N JO 7110.506

SUBJ: Takeoff Clearance

- **1. Purpose of This Notice**. This notice amends Federal Aviation Administration Order (FAAO) JO 7110.65, Air Traffic Control, Paragraph 3-9-9, Takeoff Clearance.
- **2. Audience**. This notice applies to the Terminal Services organization and all associated air traffic control facilities.
- **3.** Where Can I Find This Notice? The notice is available on the MYFAA employee Web site at https://employees.faa.gov/tools_resources/orders_notices/ and on the air traffic publications Web site at http://www.faa.gov/airports_airtraffic/air_traffic/publications.
- **4. Explanation of Policy Change**. This change corrects an error in the placement of the example phraseology within the paragraph.
- **5. Procedures**. Change FAAO JO 7110.65, Air Traffic Control, Paragraph 3-9-9, Takeoff Clearance, to read as follows:

FIG 3-9-12
Runway/Taxiway Proximity

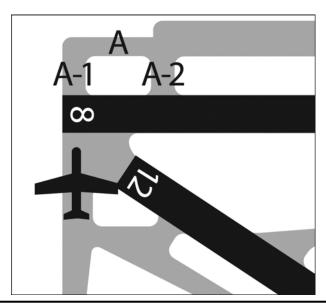
b. The controller must ensure that all runways along the taxi route that lead to the departure runway are crossed before the takeoff clearance is issued, except as stated in 3-9-9c.

FIG 3-9-13
Runway/Taxiway Proximity

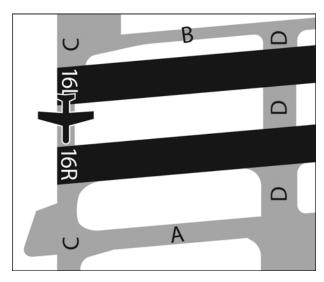
c. At those airports where the airport configuration does not allow for an aircraft to completely cross one runway and hold short of the departure runway and/or where airports do not have runway hold markings between runways, state the runway to be crossed with the takeoff clearance if the aircraft is not able to complete a runway crossing before reaching its departure runway.

CROSS RUNWAY (number), RUNWAY (number) CLEARED FOR TAKEOFF.

"CROSS RUNWAY TWO FOUR LEFT, RUNWAY TWO FOUR RIGHT, CLEARED FOR TAKEOFF.
